# SWAG 37 92 8798, 37 93 0167, 70 94 0717

Fiat Ducato II, III; Iveco Daily III, IV, V and VI

Engine: 2.3-litre JTD F1AE

## Air Conditioning Compressor Auxiliary Drive Belt

Fig 1 - Auxiliary drive diagram (up to and including engine No. 0113089), fitted with tensioner pulley 37 93 0167 and multi V-ribbed belt 37 92 8798.

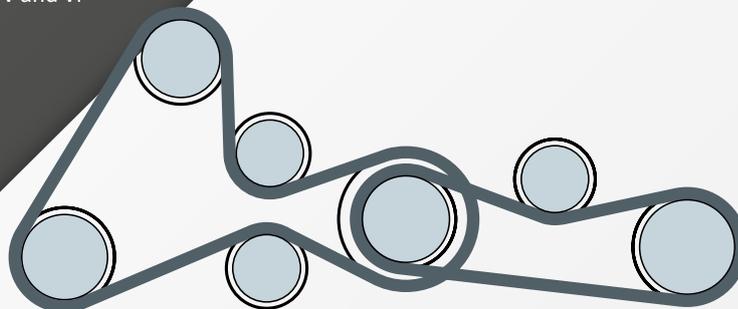
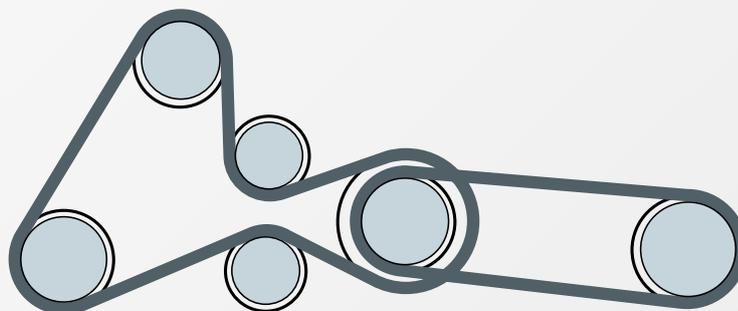
During the production period, Fiat and Iveco updated the layout routing and size of the auxiliary drive belt for the air conditioning compressor. This is applicable on several models fitted with the 2.3-litre JTD engine, starting from engine No. 0113090.

The update completely removed the requirement for the tensioner pulley used with the conventional 987 mm multi V-ribbed belt, fitted up to and including engine No. 0113089. (Fig1)

This was replaced with a shorter 903 mm elastic multi V-ribbed belt, which is routed as per the diagram above. (Fig2)

Note: for vehicles fitted with engines up to and including engine No. 0113089, this can also be retrofitted with the elastic multi V-ribbed belt 70 94 0717 during routine maintenance. This eliminates the requirement for the tensioner pulley altogether.
